SERVICE MEMORANDUM

MGF/15

DISTRIBUTOR CLAMPING

MGA TWIN-CAM

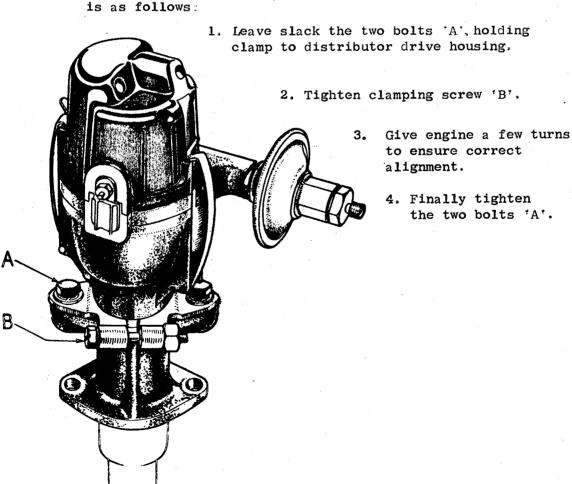
Excessive wear of the distributor driving gears is indicative of misalignment of the distributor with its drive, causing stiffness and consequent excessive loading of the gears,

This misalignment is due to incorrect tightening of the distributor clamp. The proper sequence of operations

4. Finally tighten the two bolts 'A'.
